CENPD-283-NP-A

Boiling Water Reactor Emergency Core Cooling System Evaluation Model:

Code Sensitivity for SVEA-96 Fuel

SAFETY EVALUATION BY THE OFFICE OF NUCLEAR REACTOR REGULATION
RELATING TO TOPICAL REPORT CENPD-283-P
"BOILING WATER REACTOR EMERGENCY CORE
COOLING SYSTEM EVALUATION MODEL:
CODE SENSITIVITY FOR SVEA-96 FUEL"

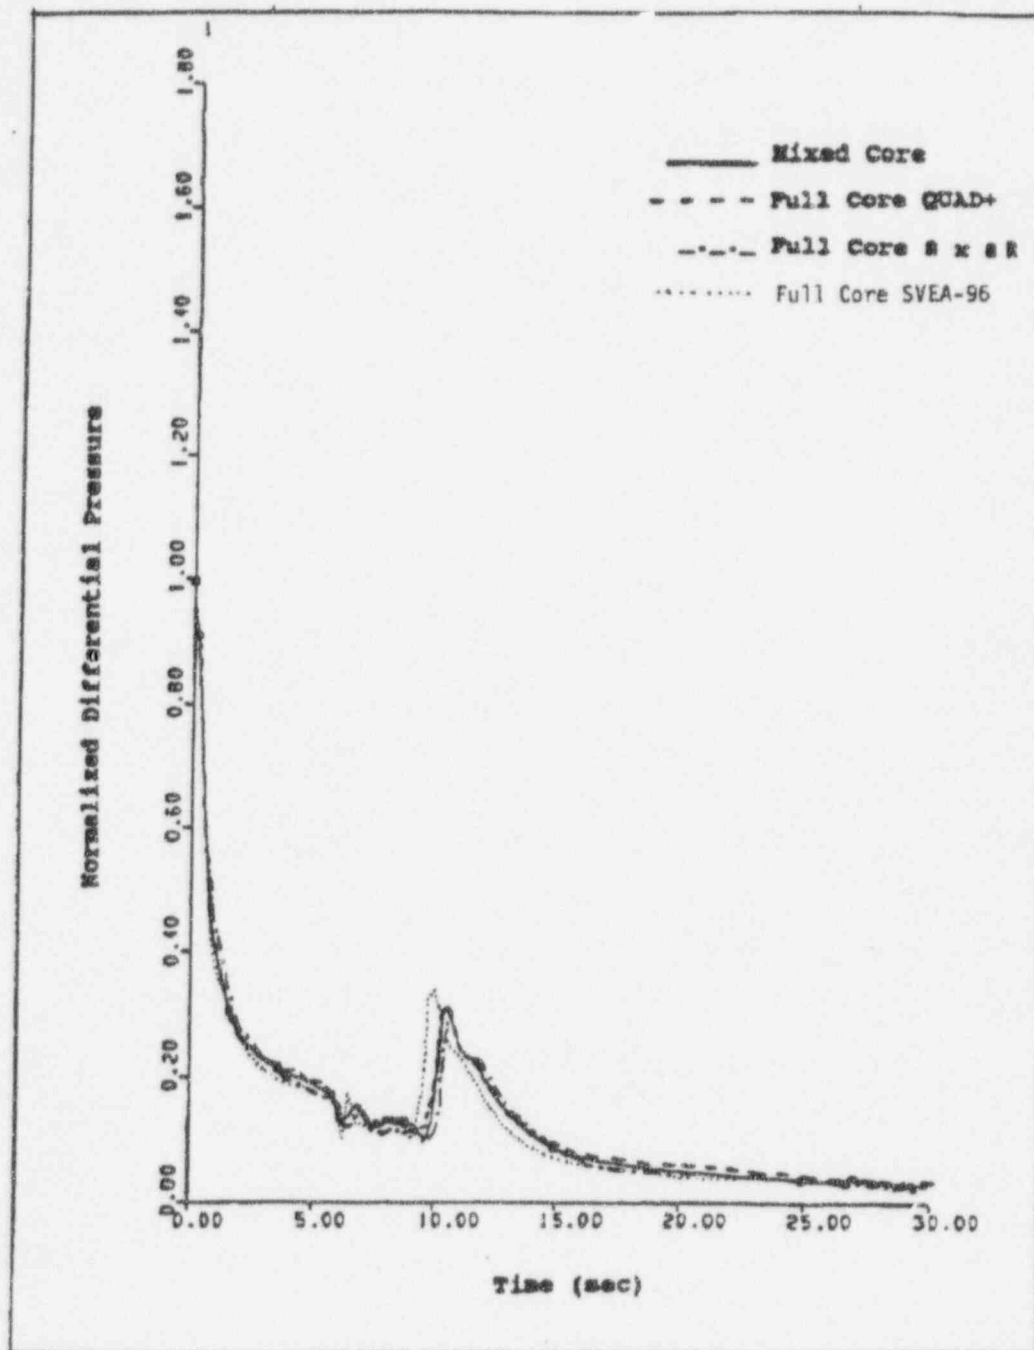
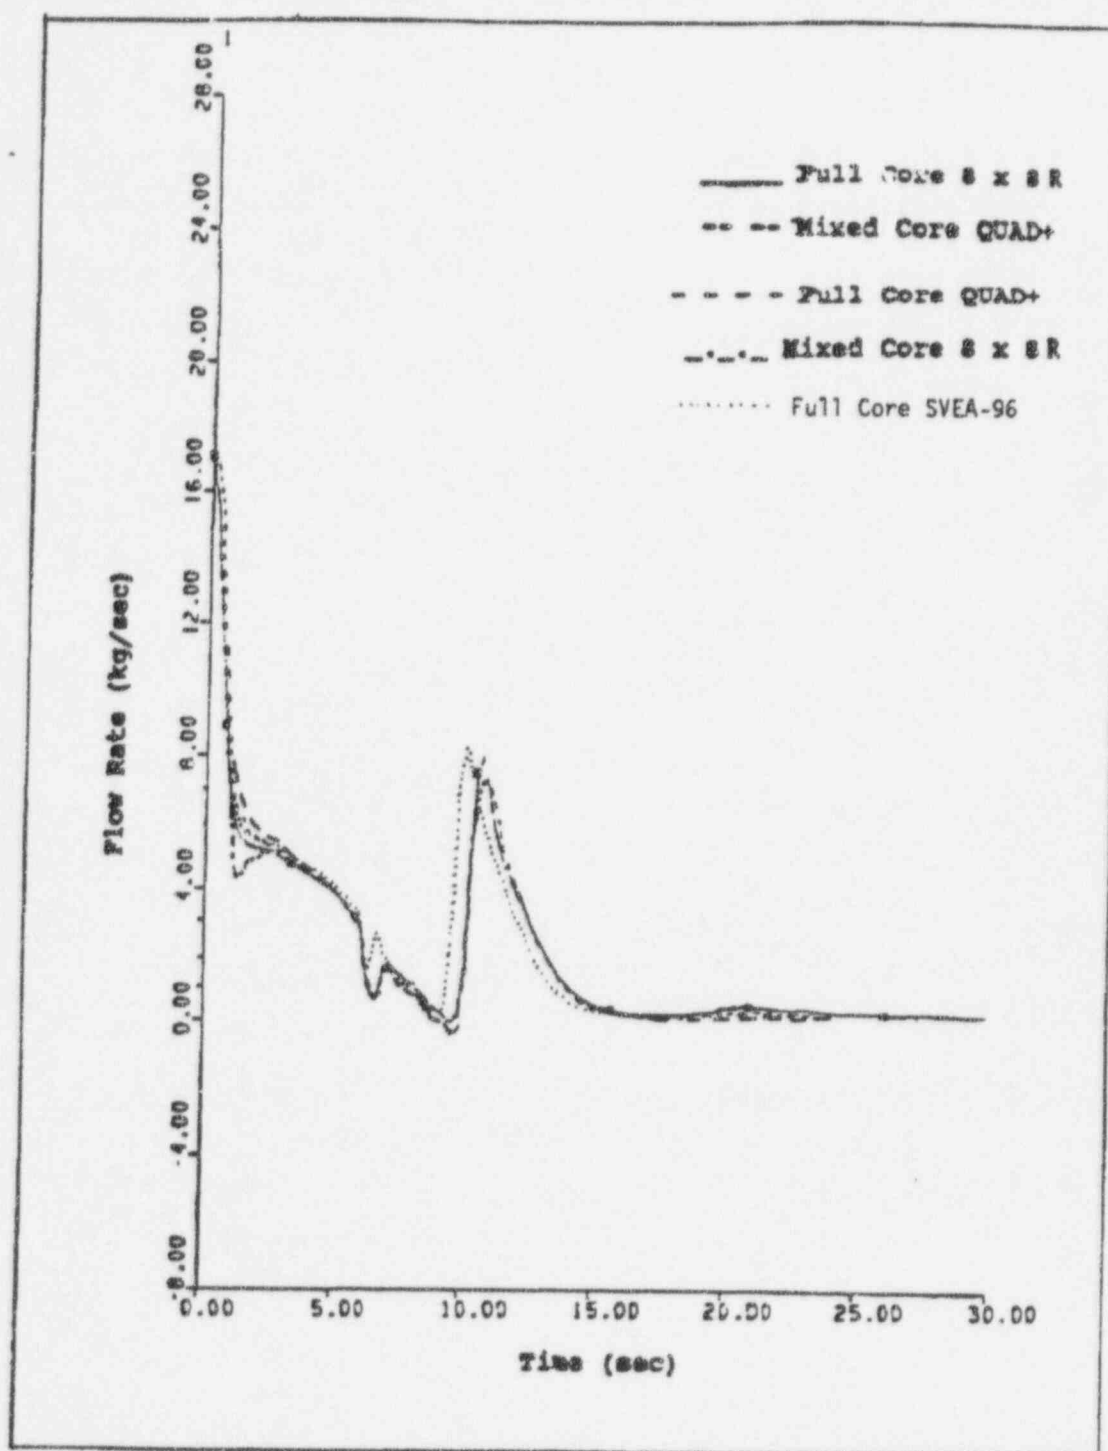
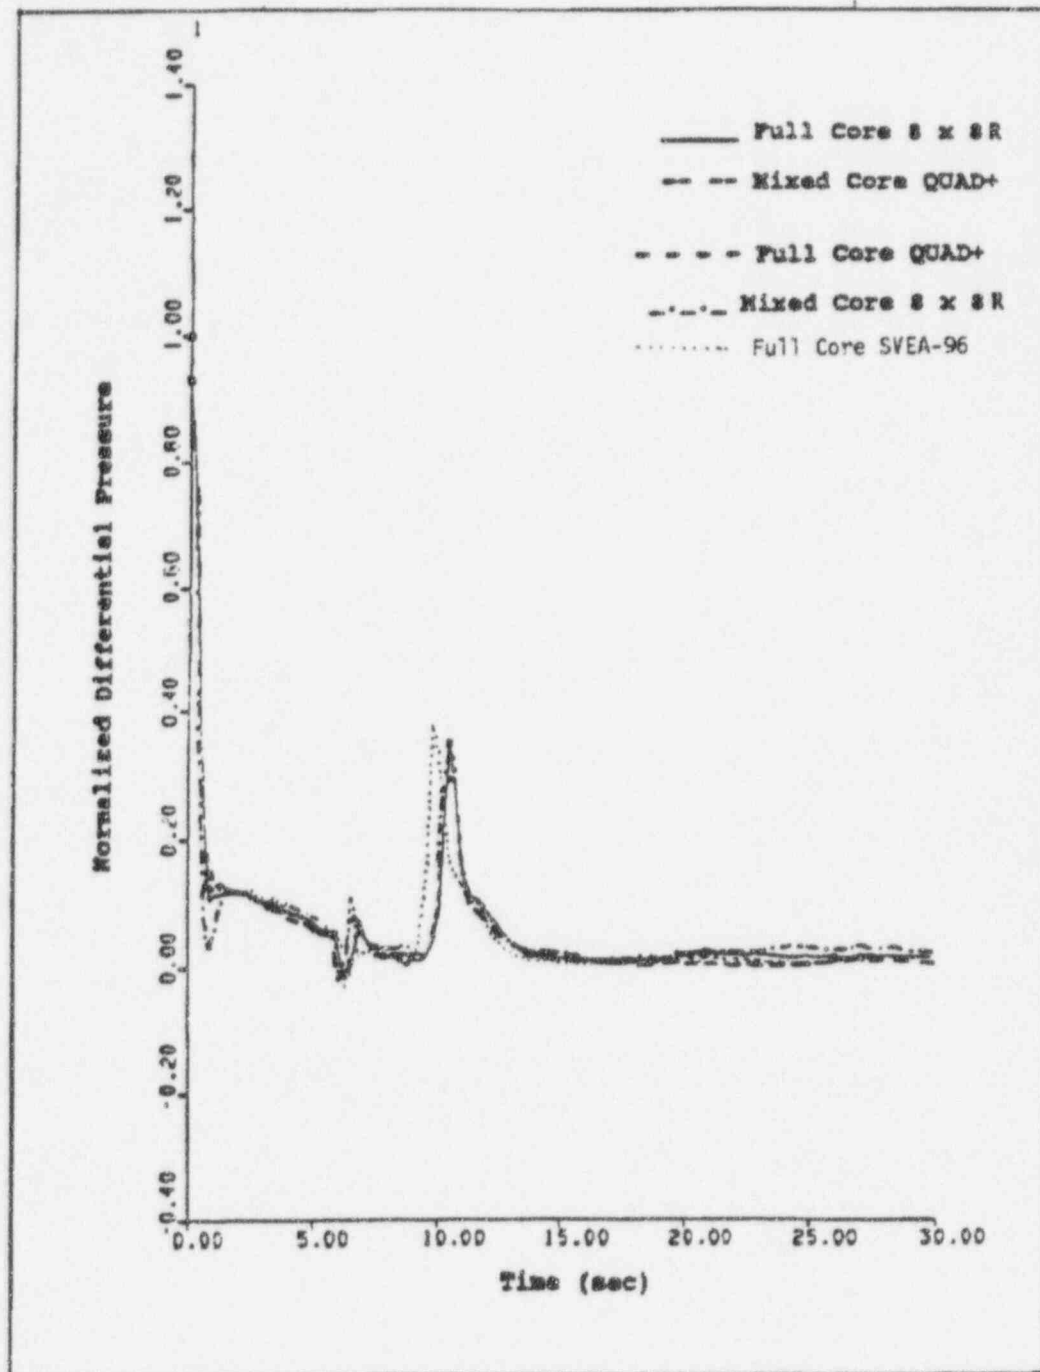
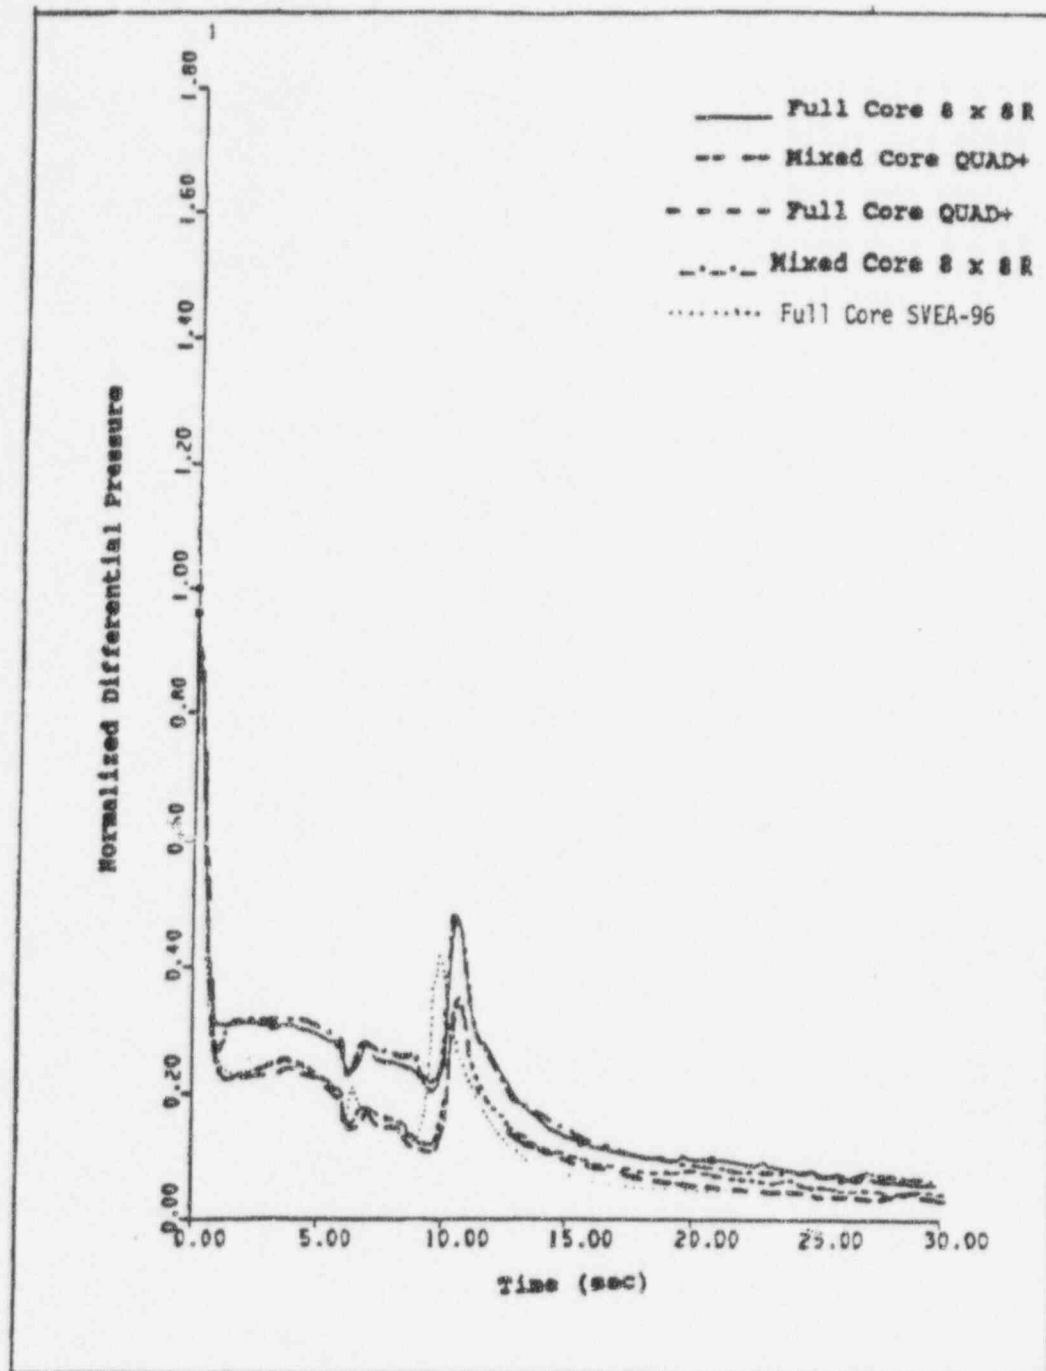
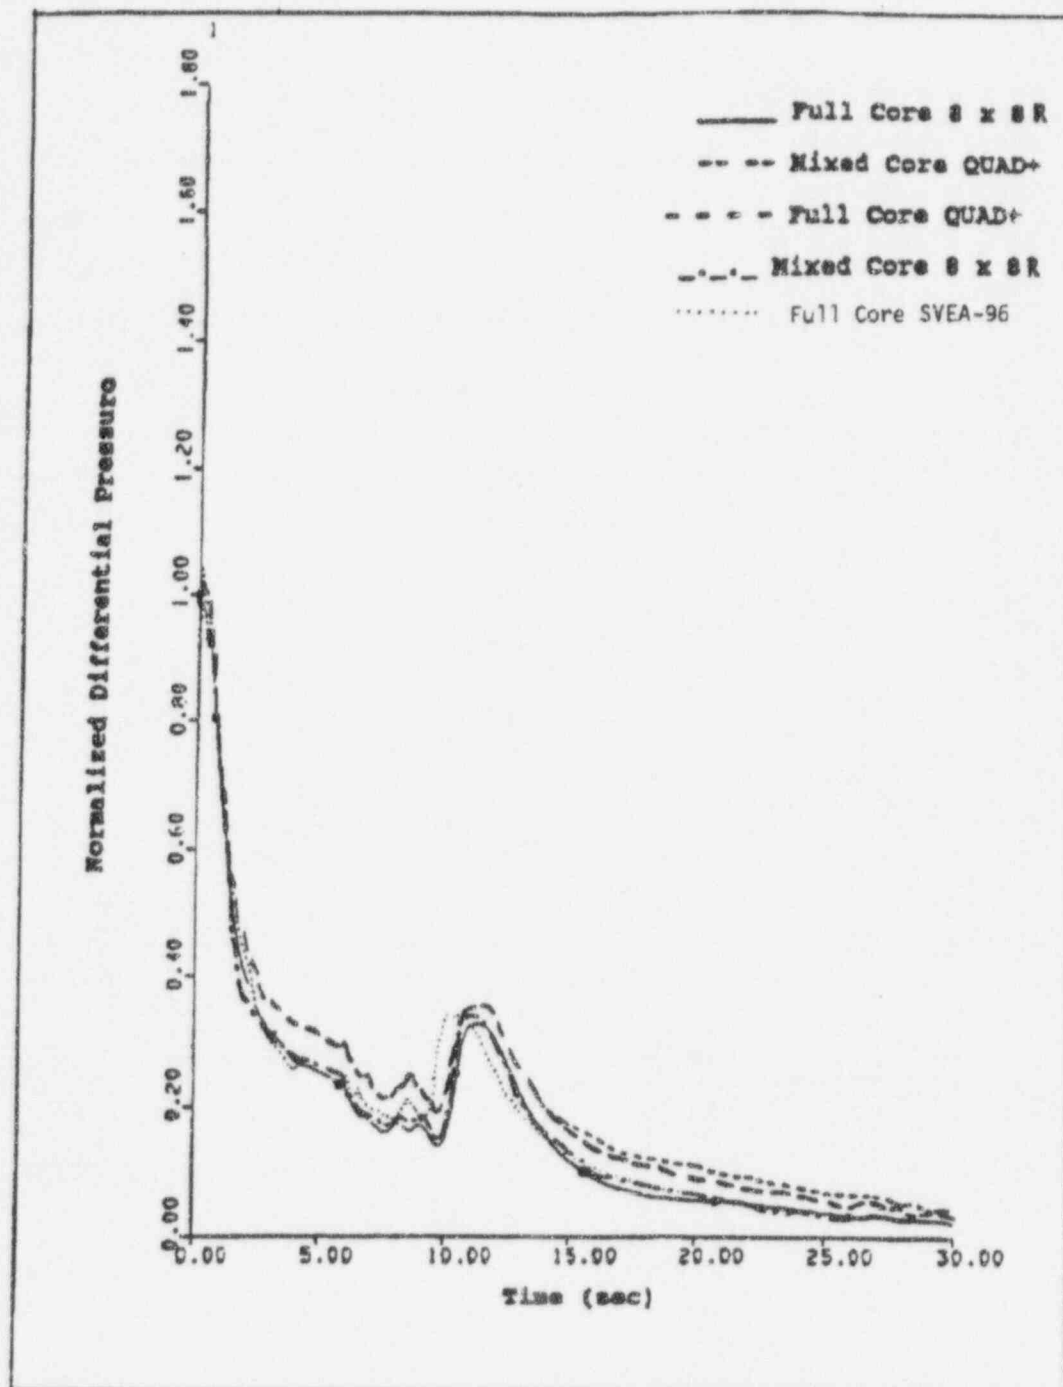
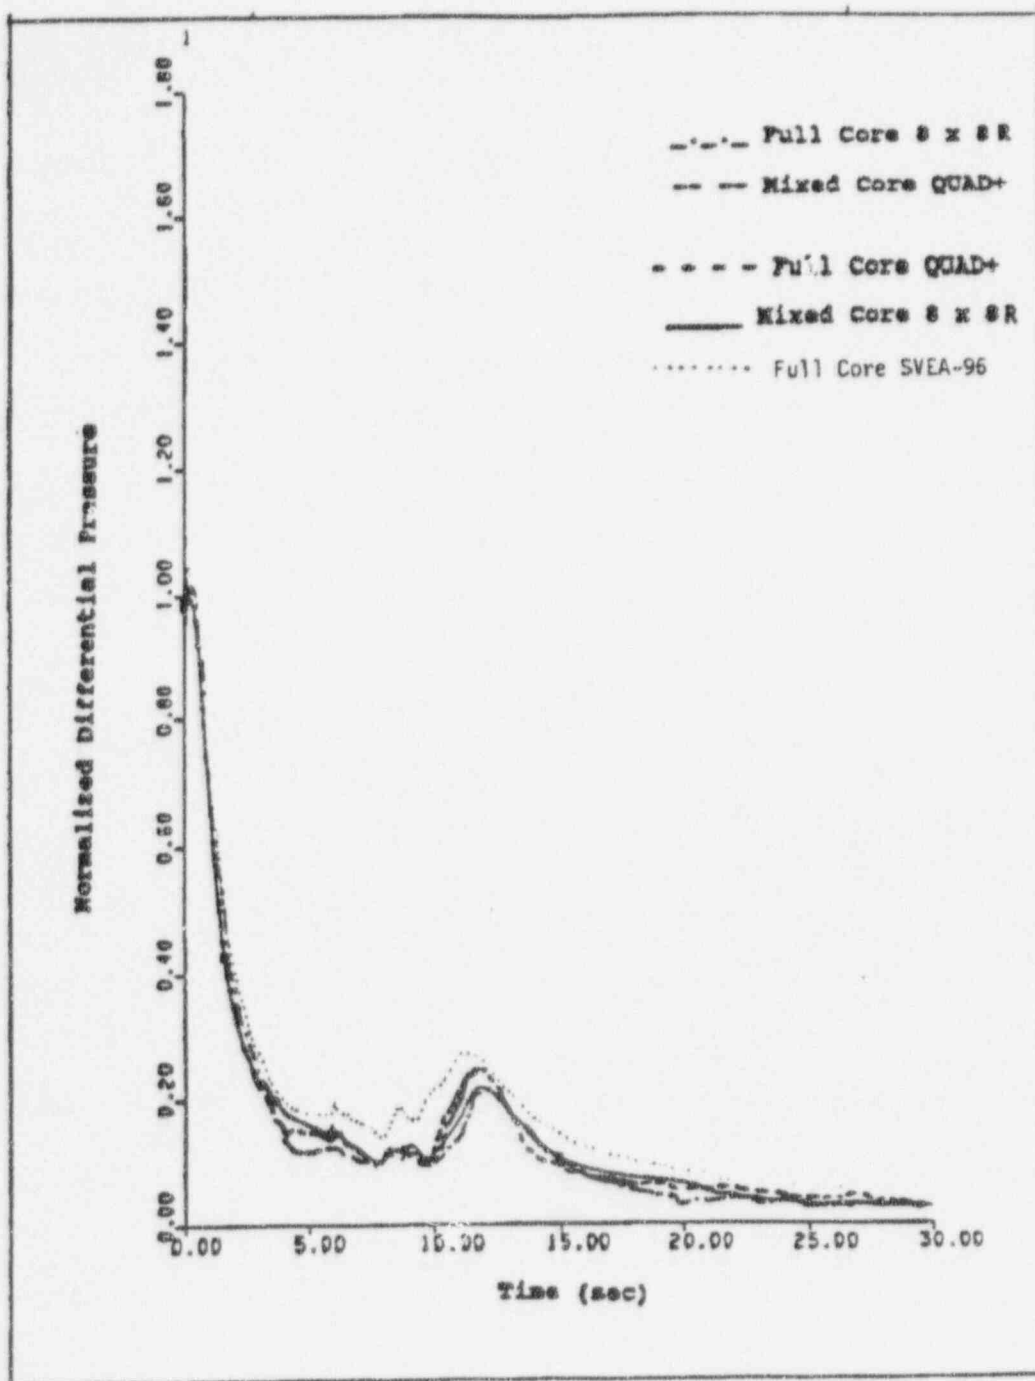
Mixed core effects should be investigated further to support ABB/CE's position regarding the transition cores by presenting mixed core analysis results with transition from QUAD+/SVEA64 fuel to SVEA-96 fuel. The watercross for each fuel design should be explicitly modeled in the nodalization. Provide plots from core void fraction, pressure, flow, and flow velocities.

Reload cores of mixed fuel designs are designed to be hydraulically compatible (See Response A1 of this document). Cores designed to be hydraulically compatible are generically demonstrated in Reference A5, to yield a LOCA reactor system response that is insignificantly altered relative to that of a full core of one fuel design. A full core of one fuel design is used in the LOCA evaluation for that specific fuel design. Hence, the industry accepted process of performing LOCA evaluations for a specific fuel design based on a full core of that fuel design is also valid for mixed core applications.

To further demonstrate that the discussion presented and conclusions drawn in the response to Question 5 of RPB-90-94-P-A are valid in general, the results for a full core of SVEA-96 were compared to the previous system responses in Section 8 of this report. Additional comparative results are shown in Figures A9-1 through A9-8 which correspond to Figures 5-1 through 5-8 on pages 18 through 25 of the Addendum to RPB 90-94-P-A. The core compositions in the four cases presented in Figures A9-1 through A9-8 are:

For the Mixed Core case, as applicable, both QUAD+ and 8x8R channel results are shown in the figure. There are insignificant differences between the system responses of the four cores presented.

As discussed in Response 5 of RPB-90-94-P-A small differences in the responses are attributed to differences in fuel component designs. As noted in Response A1 of this document, the SVEA-96 core used as an example was not specifically designed to be hydraulically comparable with the previous example cores (i.e., QUAD+ and 8x8). Hence, in some instances in Figures A9-1 through A9-8, the SVEA-96 results deviated slightly more than those observed for the other cores configurations. However, the overall system responses are very similar.

The results presented here further substantiate the general conclusion that the core average system response is relatively independent of local differences in fuel assembly design.
